## PRE-BID ADDENDUM NO. # 1

**PROJECT:** Orange County Community College  
Physical Education Center HVAC Roof Top Unit #7-12 Replacement  
OCCC Project No. ITB-OCCC-2023-19  
F.E. Project No. 22-059

**DATE:** October 26, 2022

SKETCH No:  
**SKHE-100.1**

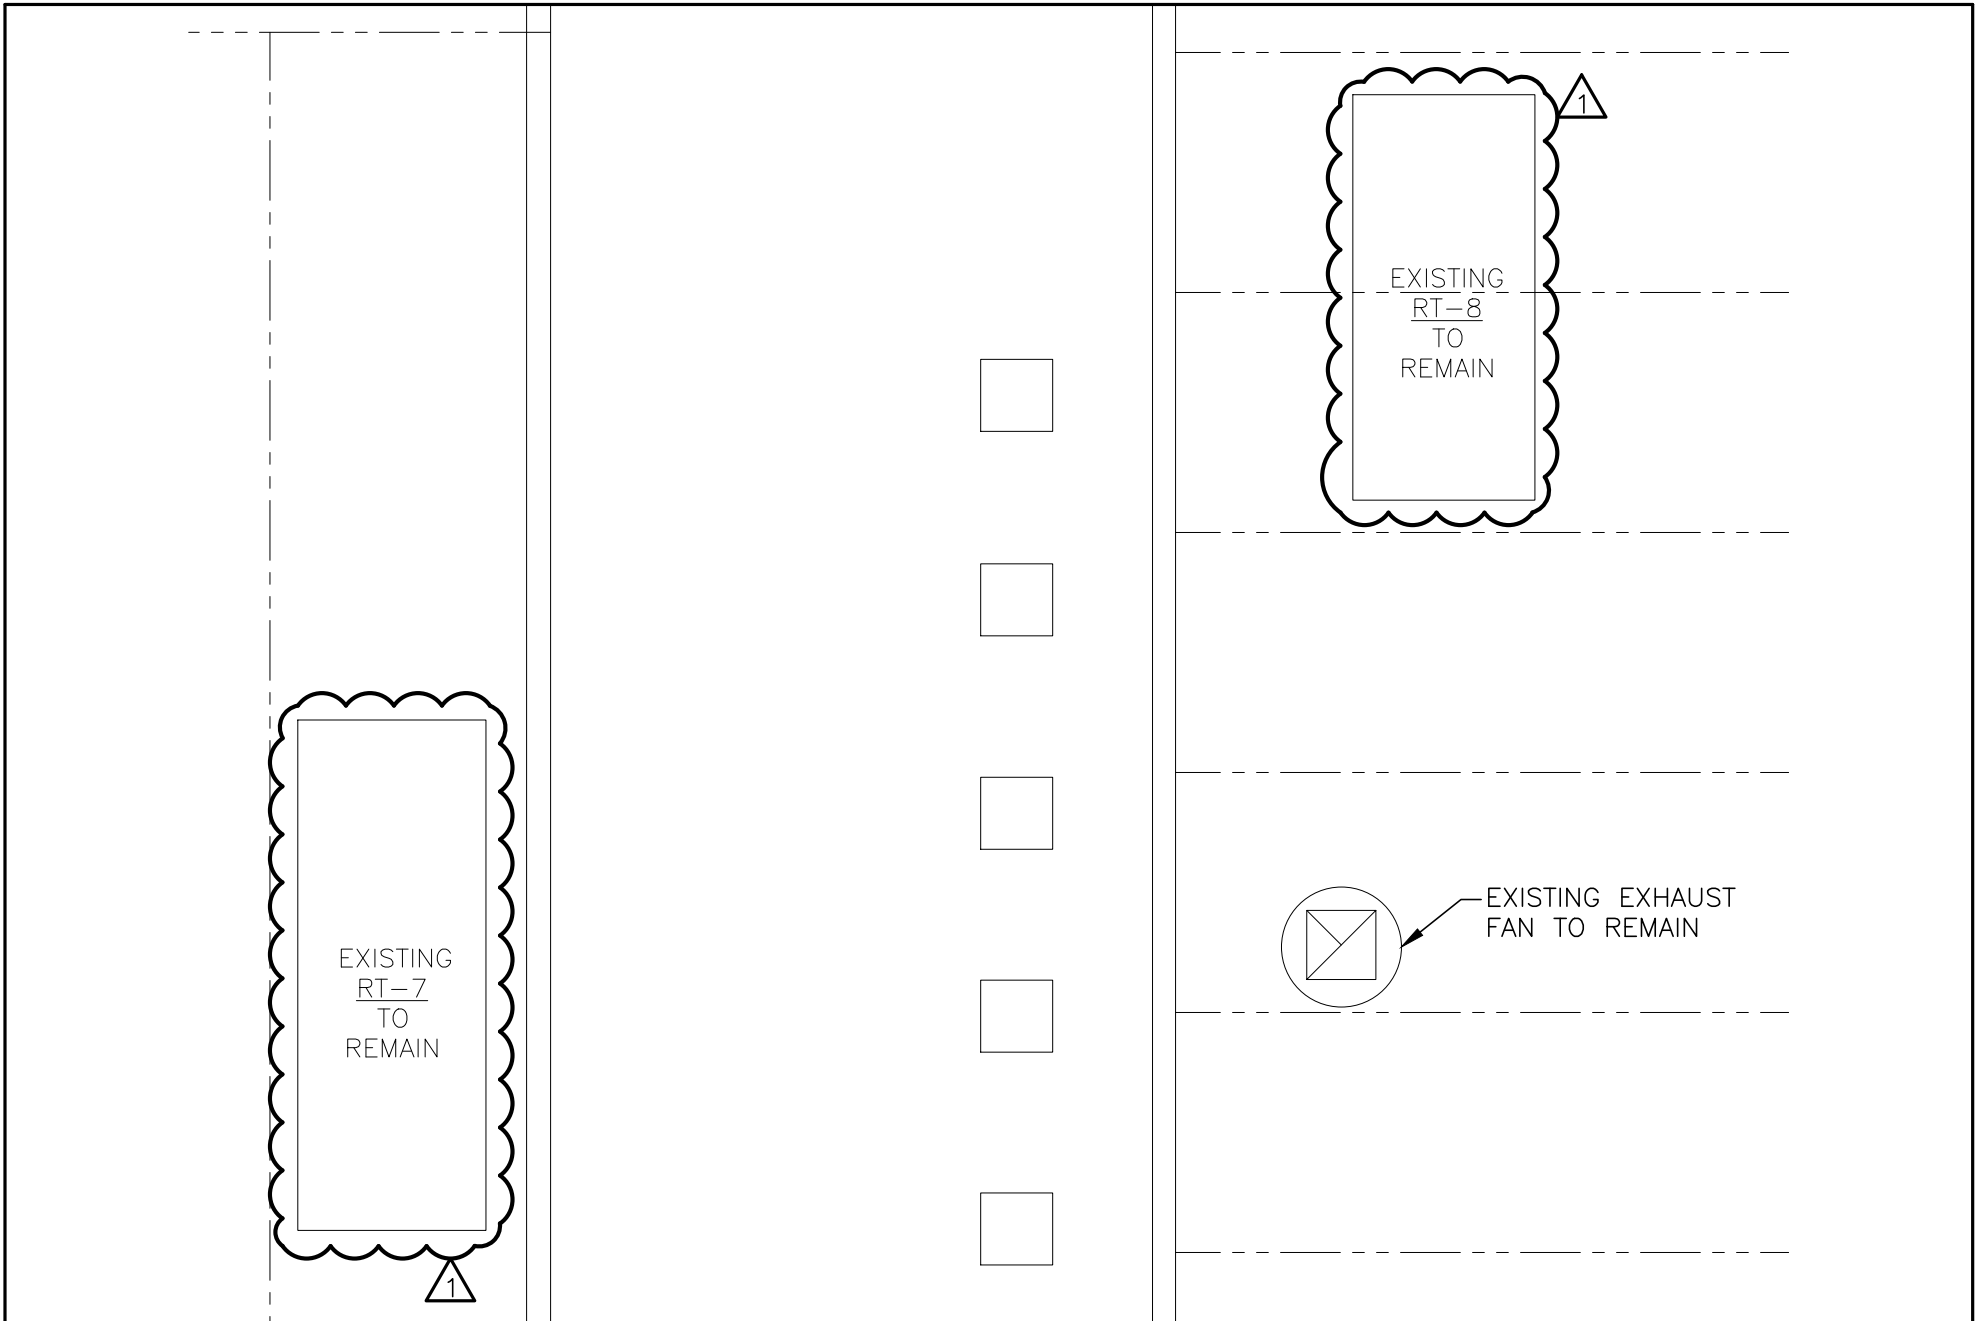
1. See attached sketches SKHE-100.1, SKHED-104.1, SKHED-104.2, SKHE-102.1, SKHE-103.1, SKHE-104.1, SKHE-104.2, SKHE-104.3, SKHE-701.1, SKHE-701.2 and SKHE-702.1.
2. RT-7, 8 and 9 have been removed from the project's scope of work. The revisions are shown on sketches SKHE-100.1, SKHED-104.1, SKHED-104.2, SKHE-104.1 and SKHE-104.2.
3. Installation of new conduit and wire feeding RT-7 was removed. See sketches SKHE-102.1 and SKHE-103.1.
4. Details on drawings HE-701 have been revised to reflect the omission of RT-7, 8 and 9 from project scope. See sketches SKHE-701.1 and SKHE-701.2

SKETCH No:  
SKHE-702.1

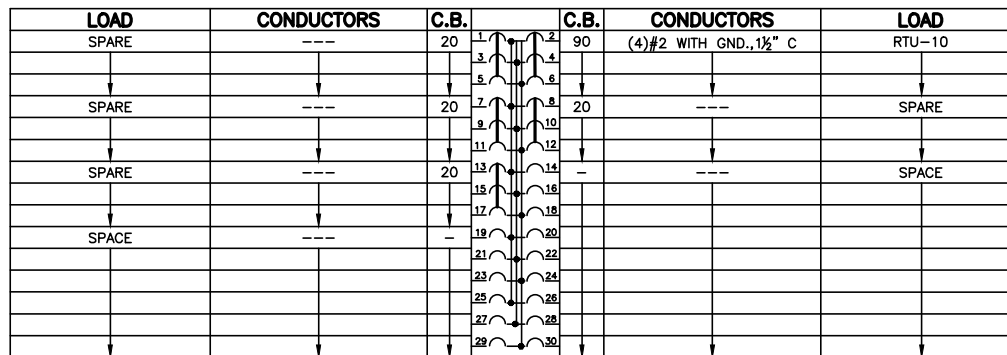
5. Roof Top Unit Schedule and PP-HVAC panel schedule on sketch SKHE-702.1 have both been revised to reflect the omission of RT-7, 8 and 9 from project scope.
